CHELAN COUNTY NATURAL RESOURCE DEPARTMENT
BEAVER CREEK CULVERT REPLACEMENT PROJECT

ADDENDUM NO. 2

TYPICAL ROAD SECTION
SCALE: 1" = 4'

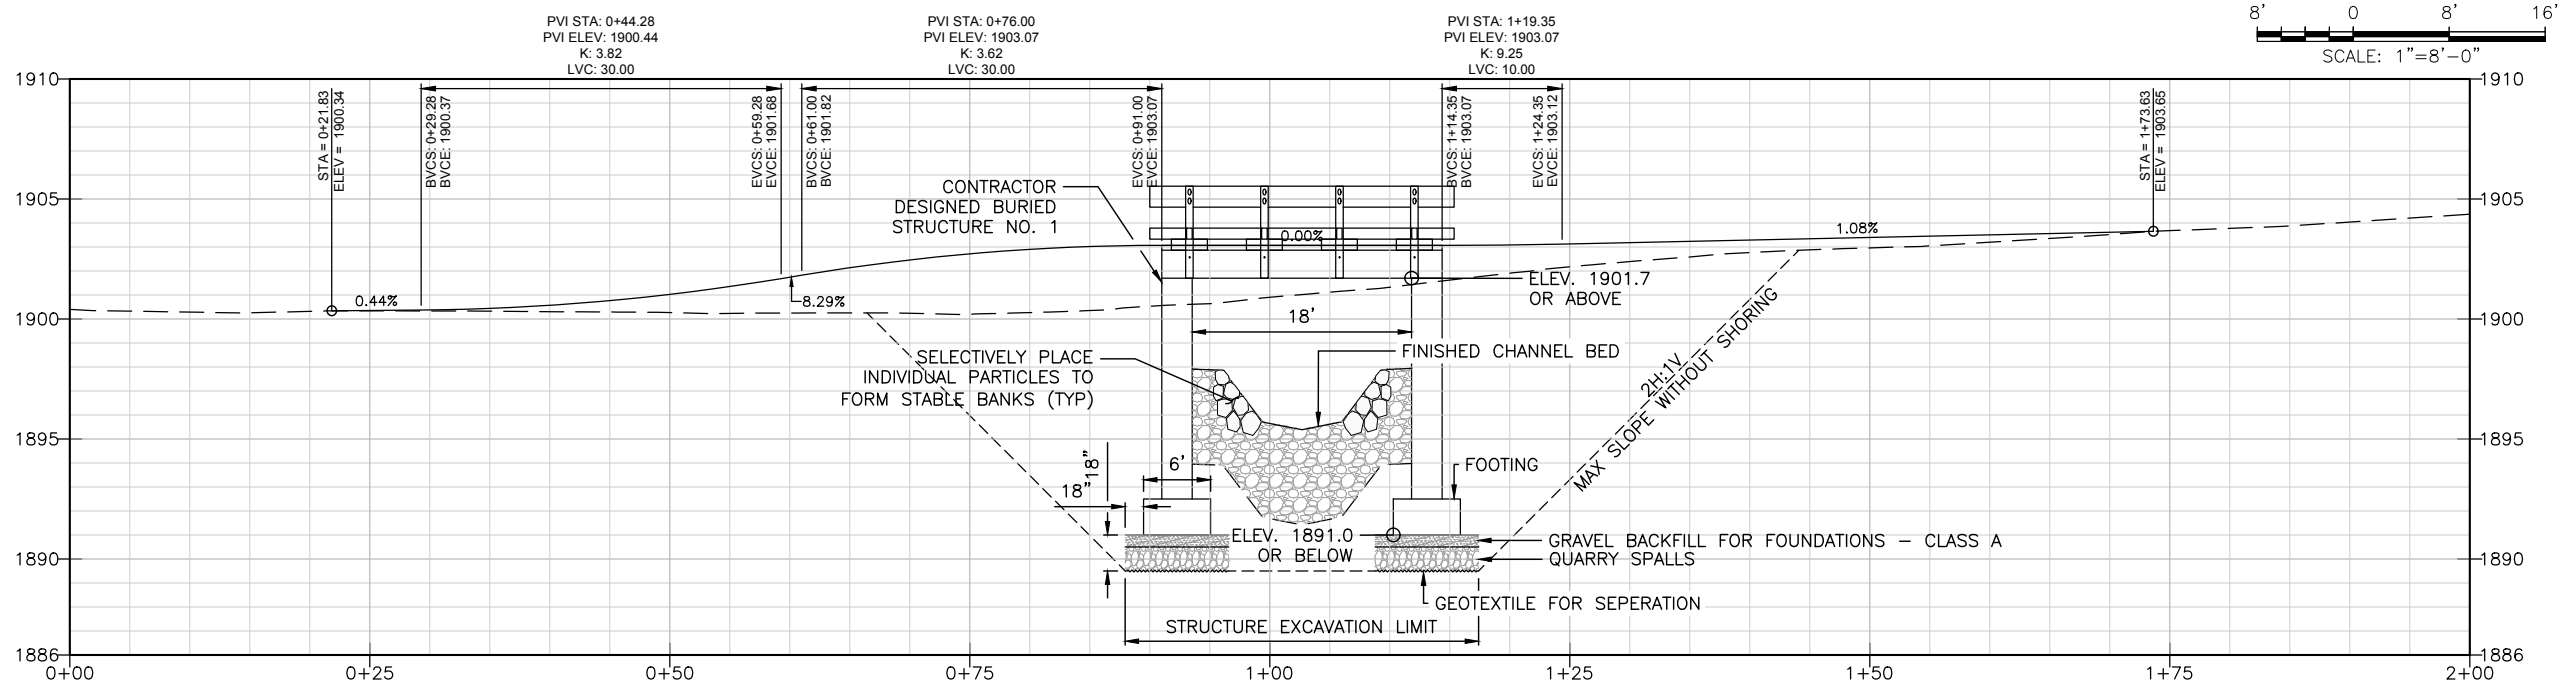
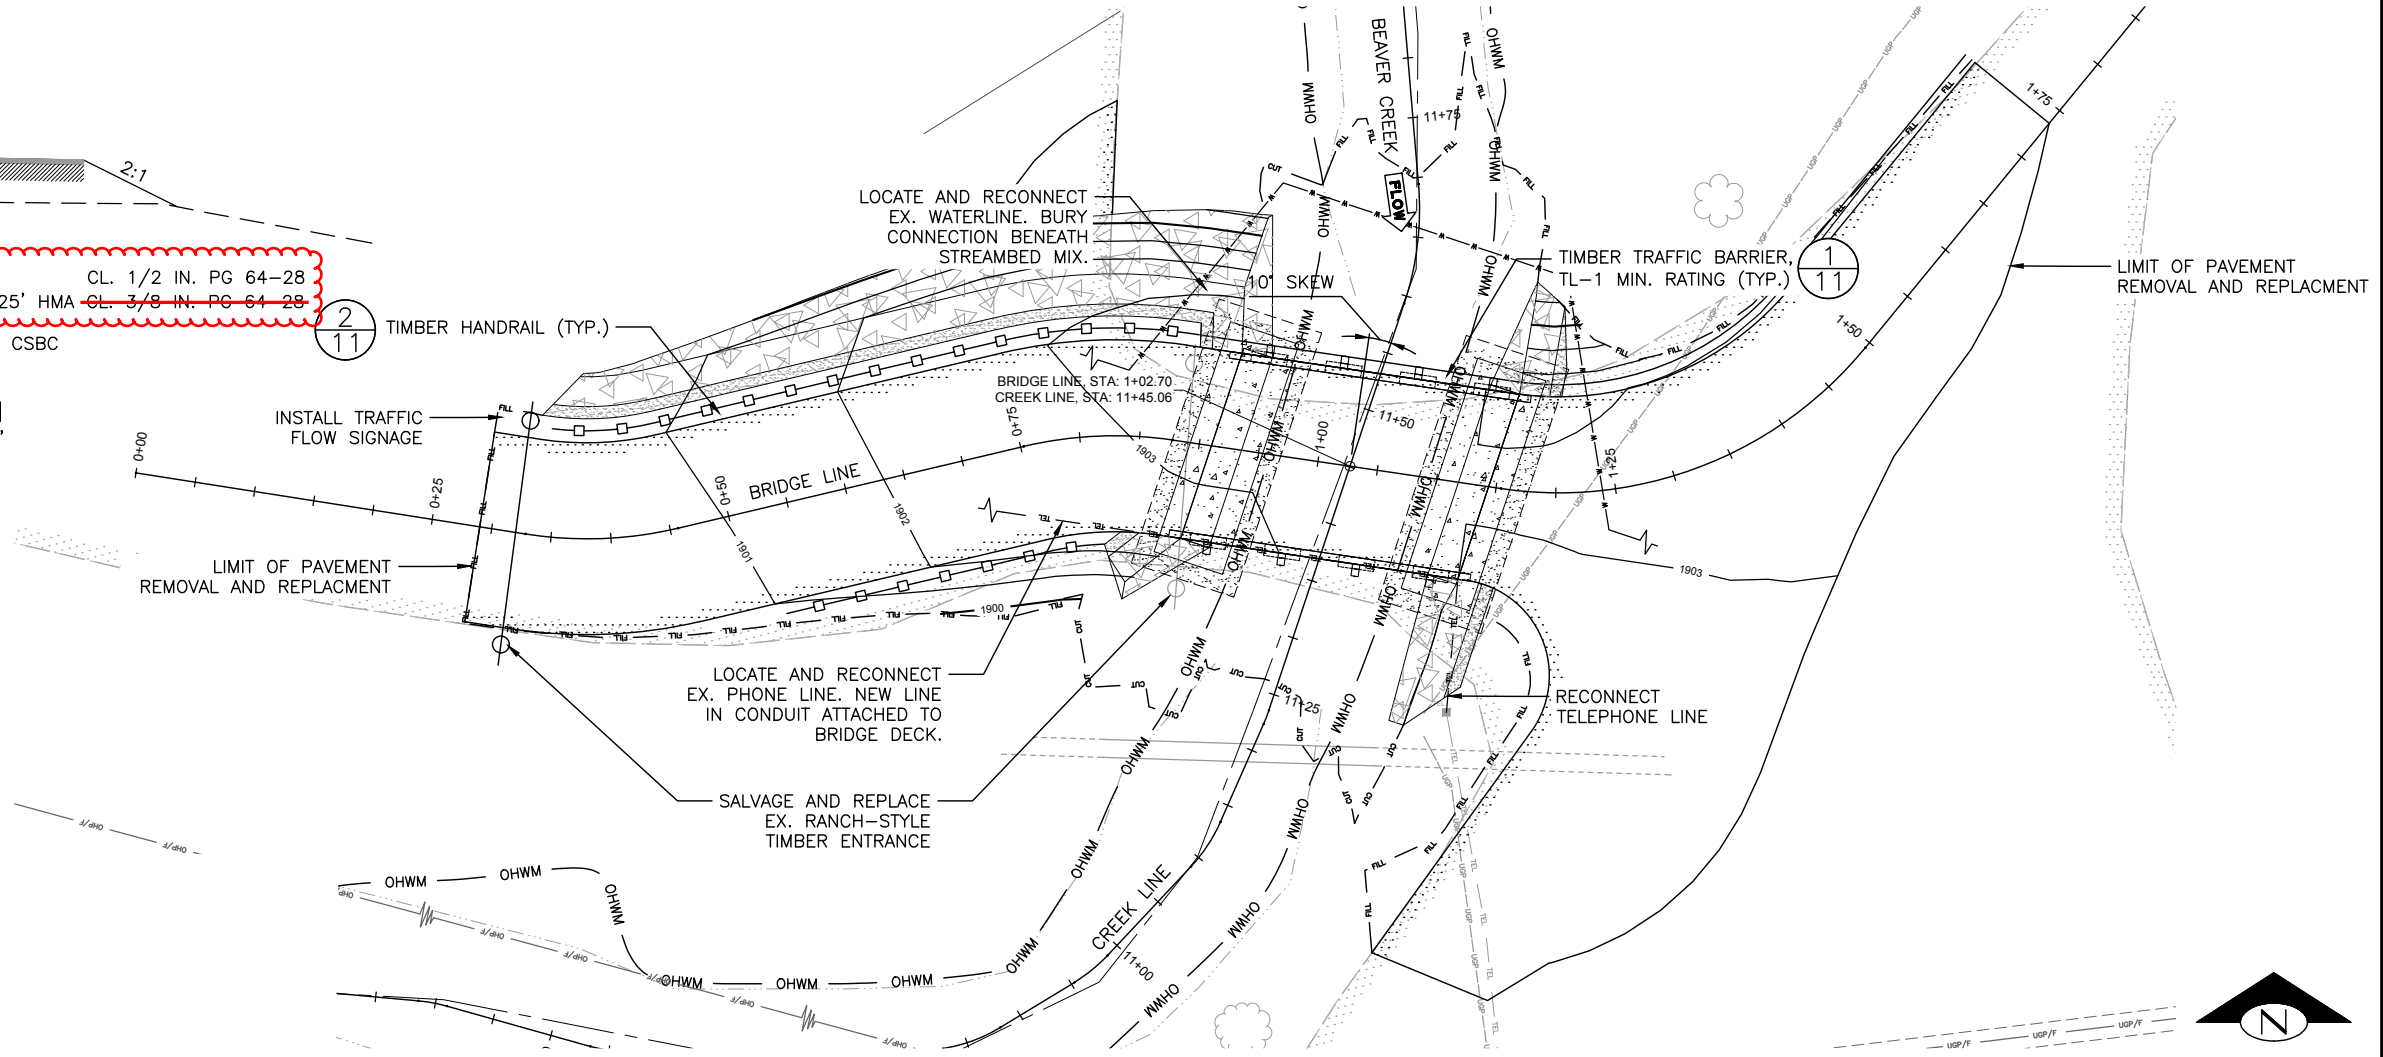
A.1. Sheet 8; Typical Road Section

Sheet 8 of the Final Contract Drawings is updated to reflect a correction to the HMA type shown in the typical road section. As shown in the bid form, HMA for the project shall be HMA CL. 1/2 IN. PG 64-28.

REV 1: CORRECT HMA CLASS CALLOUT *NT 2-21-2024*
